Planning Commission Staff Report

Consideration of a request to rezone approximately 5 acres located at approximately 730 South Main Street from Agricultural-Residential (A-2) to Residential Agricultural (RA-1) with the TDR-Receiving Overlay and review of a Preliminary Plat for the Thatchill Estates Subdivision Plat “A” consisting of seven lots.

MAPLETON CITY DEVELOPMENT REVIEW COMMITTEE MINUTES

On or about June 10, 2019, Cory Anderson Re-submitted plans for the Thatchill Estates Subdivision, Plat "A" in the A-2 zone and located at approximately 730 South Main Street. The applicant is requesting a rezone to the RA-1 zone with the TDR-Receiving zone. The comments herein are based on the proposed zoning standards. The items below include 1) requested changes to the submitted plans, 2) other items required as part of the application and/or 3) informational items regarding city standards. **All items that include an * and are bolded are required prior to any public hearings.**

Conditions of Approval

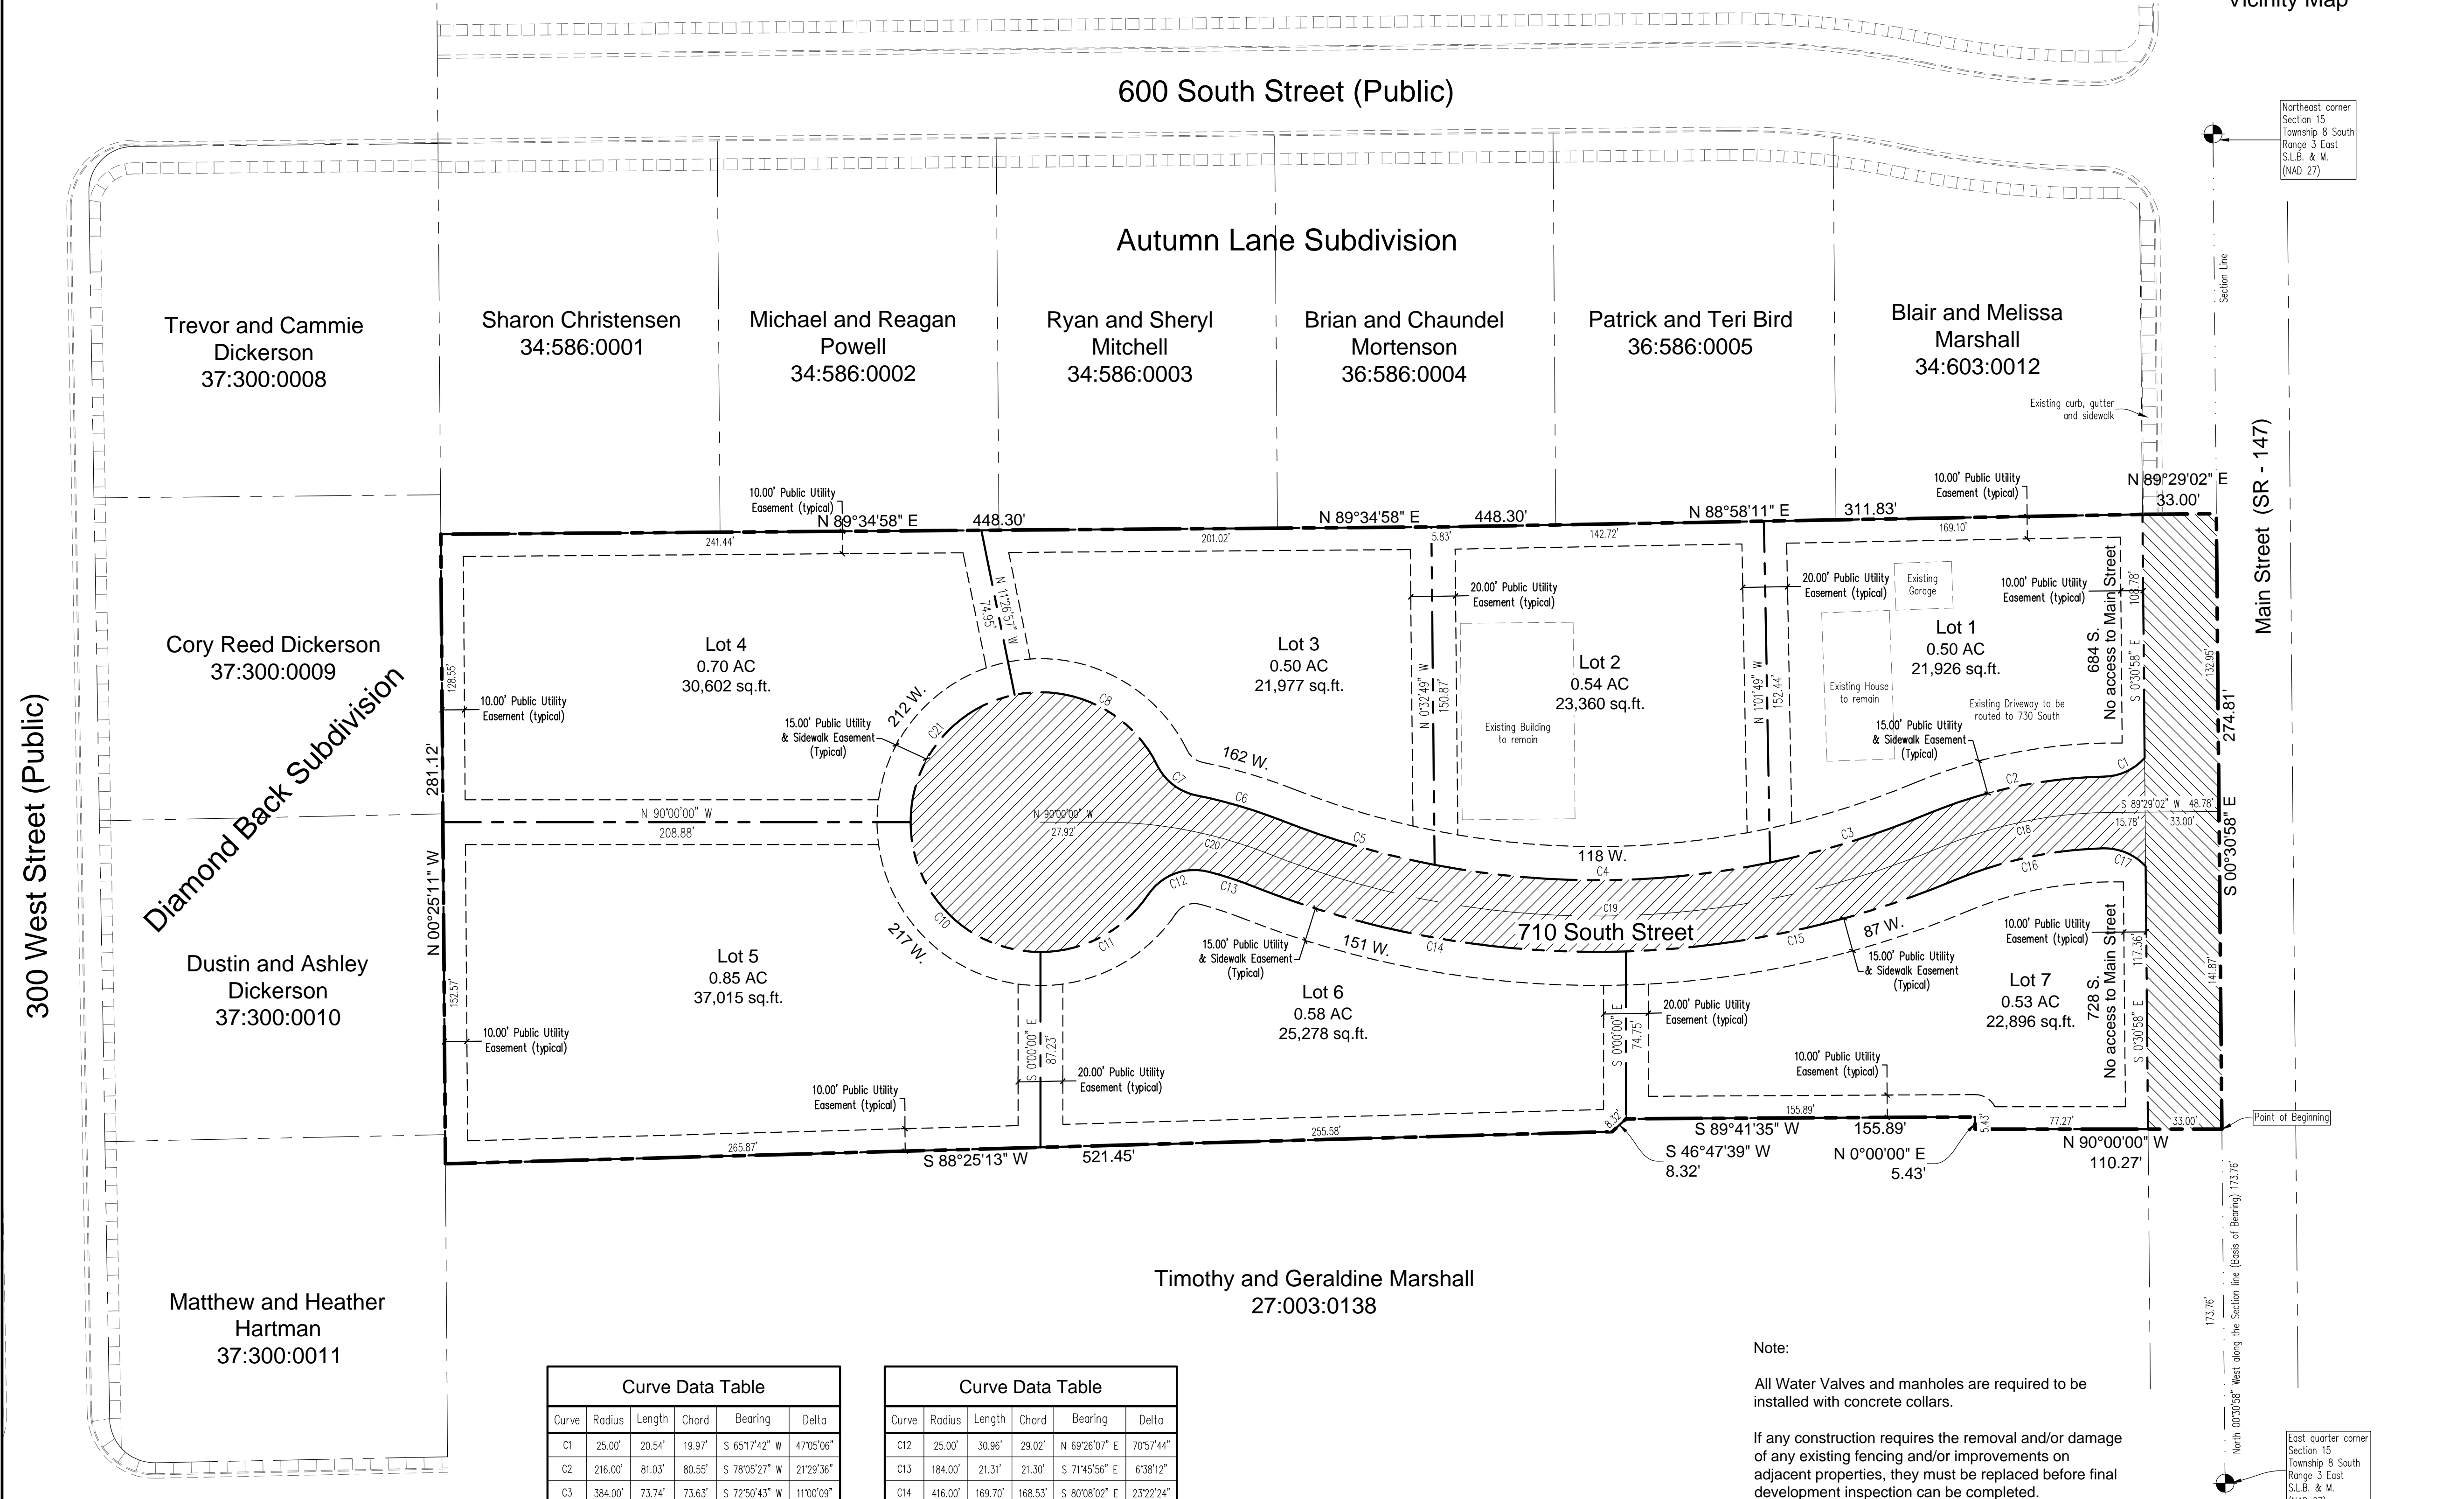
1. The final plat must include, among other requirements, the following:
 - a. A final plat stamped and signed by the Surveyor of Record.
 - b. A dedication block and signature lines for all property owners. The owners will need to sign the plat exactly as they signed the deed to the property and must print their names underneath their signatures to match the signatures. In addition, properties in trusts must include the title of the signer, the full name of the trust and the date of the trust.
 - c. The owners dedication must be accompanied by a line for the notary sign the plat, a line for the notary to print their full name, their commission number and the words "A notary public commissioned in Utah" in the signature block. **Because the owner's dedication is for a corporation, a corporate acknowledgement must be used rather than an individual acknowledgement.**

- d. A signature block for the Community Development Director to approve the plat.
 - e. In accordance with the standards of the Utah County Recorder, a space must be reserved near the bottom right hand corner for the recording certificate to be printed on the plat. The current plat doesn't make space for this certificate. Please communicate with the Utah County Recorder's Office for the specifics for this requirement.

- f. In accordance with the standards of the Utah County Recorder, the names of the Owners must be printed in the Acknowledgement as the persons who appeared before the notary. It is useful for the plat to contain a space within the acknowledgment text for the names to be written. Other standards may apply for trusts and corporations. Please communicate with the Utah County Recorder's Office for the specifics for this requirement.

Utility Plan

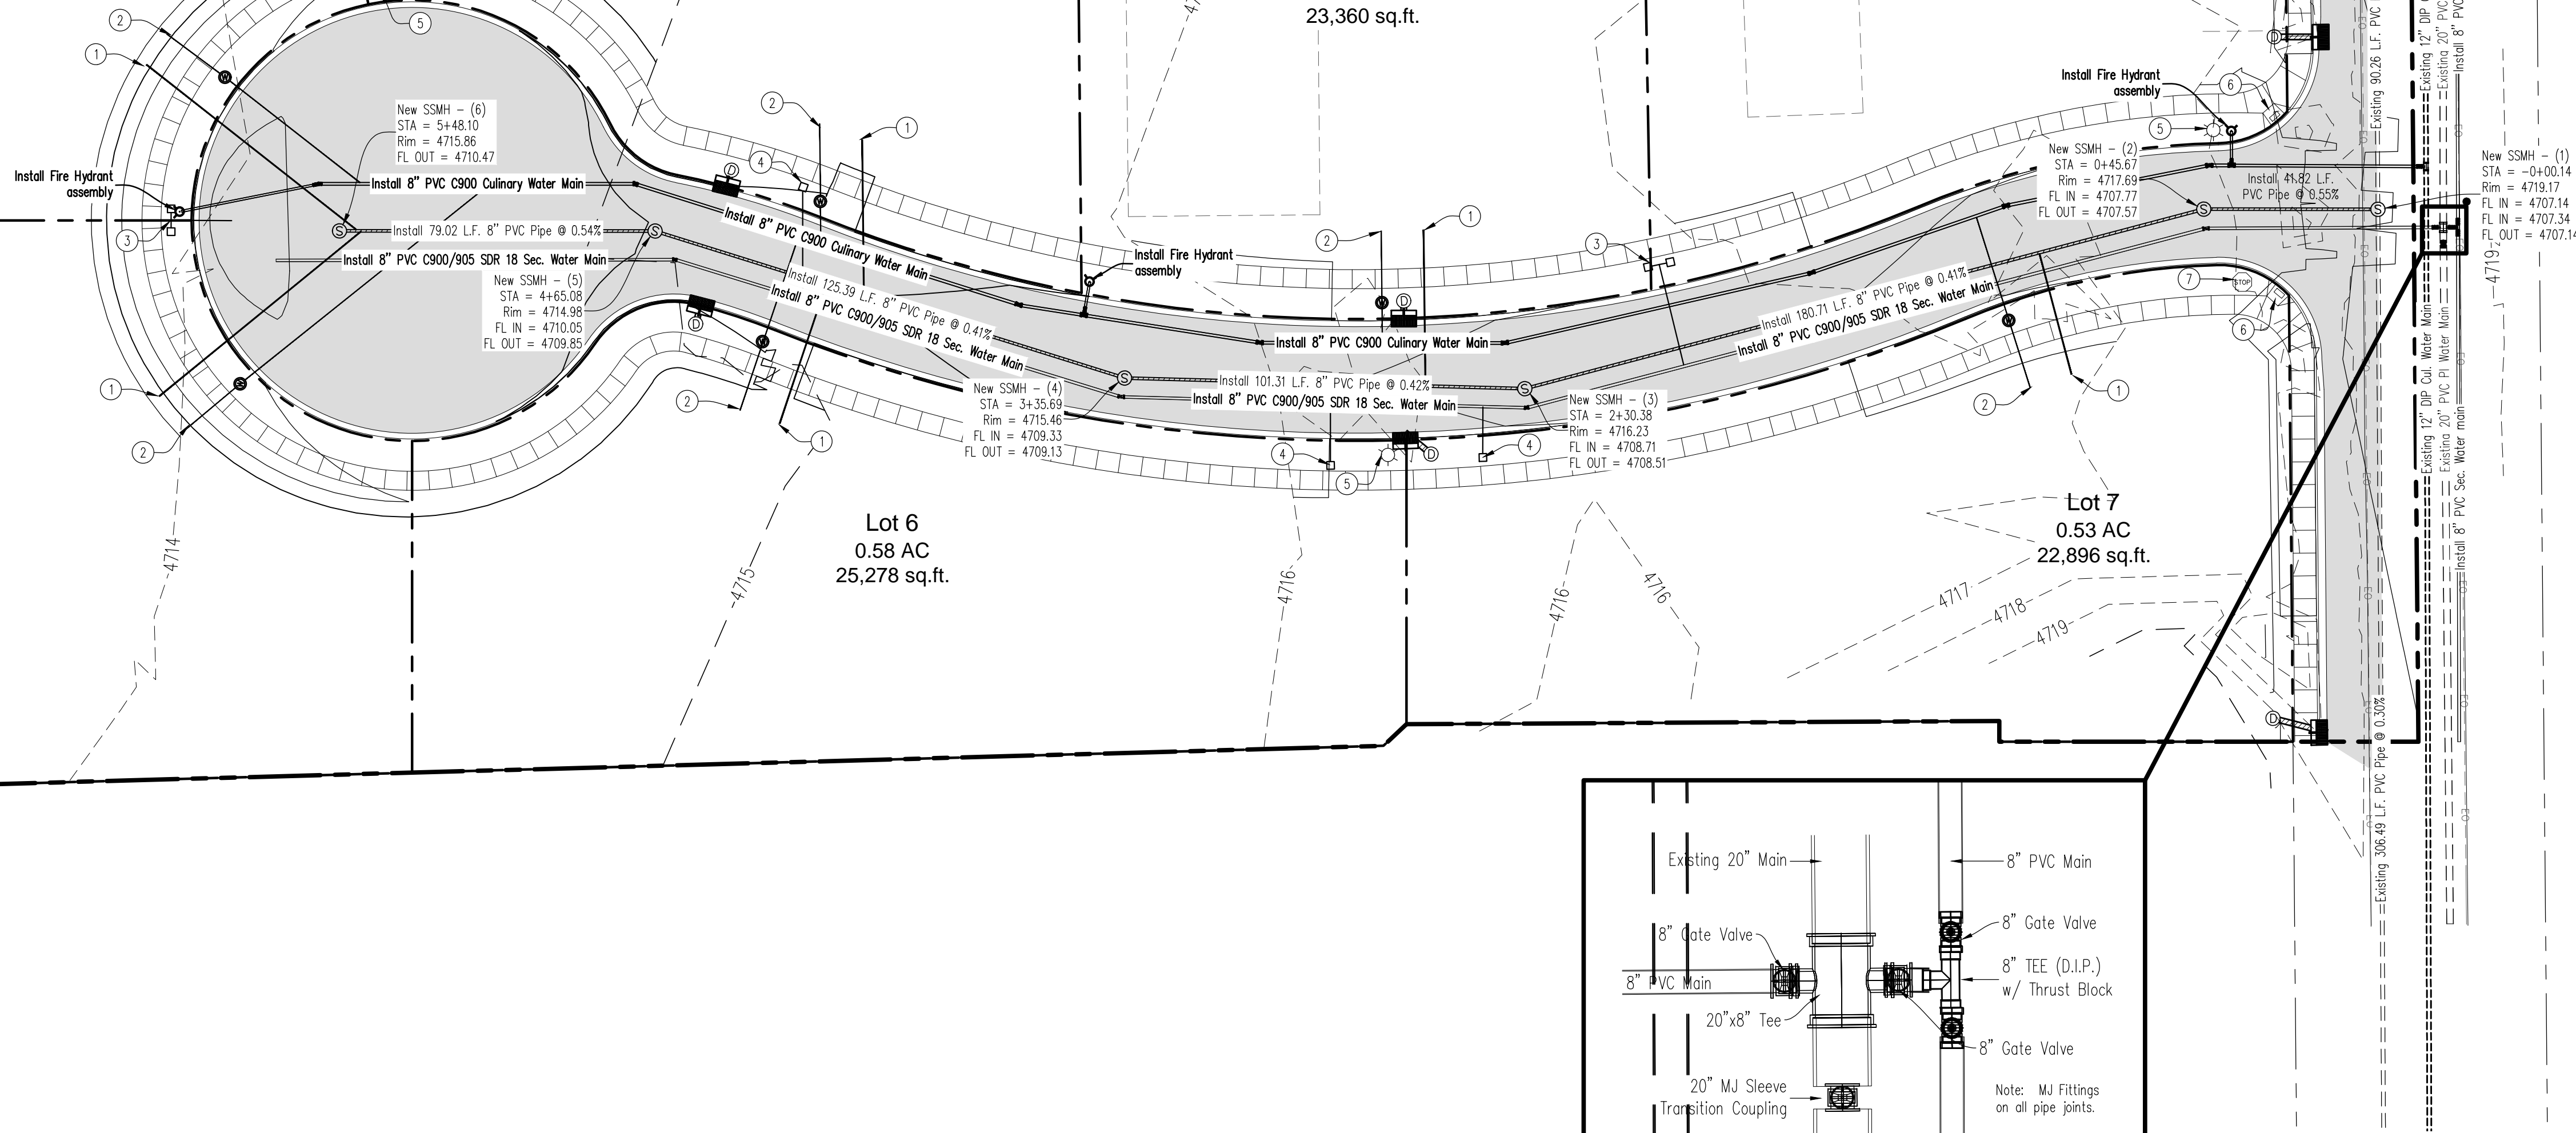
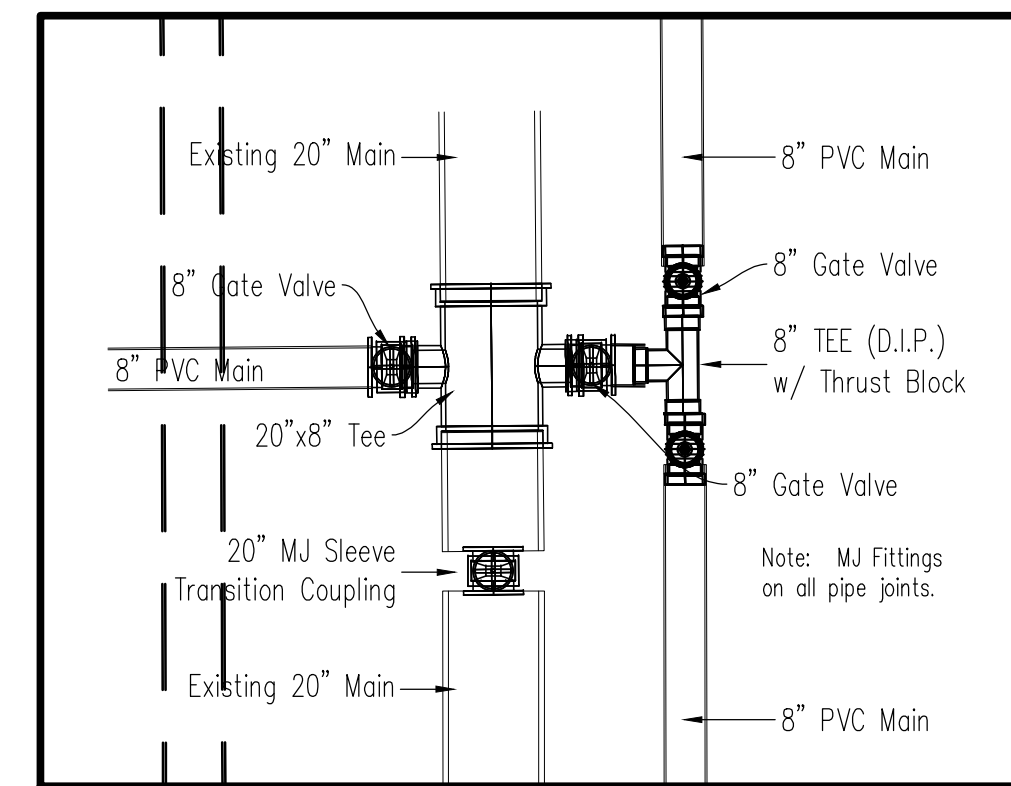
8. Concrete Collars will be required on all valves and manholes in the roadway.
9. The applicant must submit plans to RB&G Engineering (801-374-5771) to be added into the City's water model. The applicant shall be responsible for the cost of this review.

12. Any work in UDOT Right-of-Way will require a separate UDOT access and encroachment permit.
13. Please ensure 10' separation between culinary water and sanitary sewer lines.
